19-115CP – BRIGHT ROAD SENIOR HOUSING

Summary

Conceptual development proposal to establish a Planned Unit Development for a full service, 55 and over, healthcare and housing community. The 22-acre and 18-acre sites consists of 13 parcels, or a portion thereof, and are zoned R-1, Restricted Suburban Residential District, PCD, Planned Commerce District, and PUD, Planned Unit Development District.

Future Land Use Map

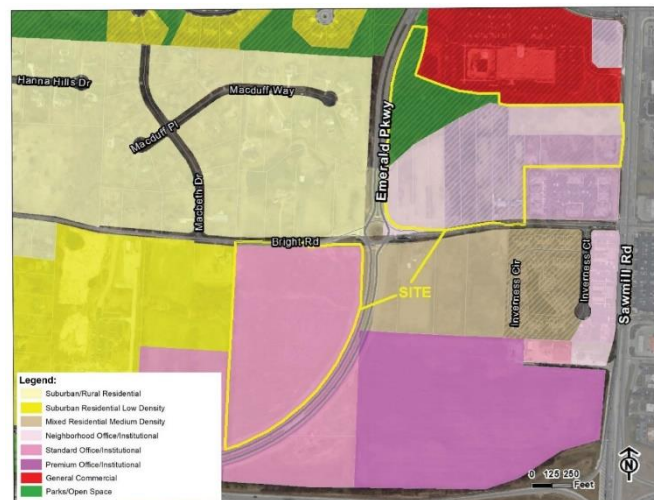
The Community Plan identifies three Future Land Use (FLU) recommendations for the two areas. The primary FLU recommendation for the ±22-acre site is Neighborhood Office/Institution, with the northwest portion of the site recommended for Parks/Open Space. The ±18-acre area is recommended for Standard Office/Institutional. In detail, the Community Plan recommends:
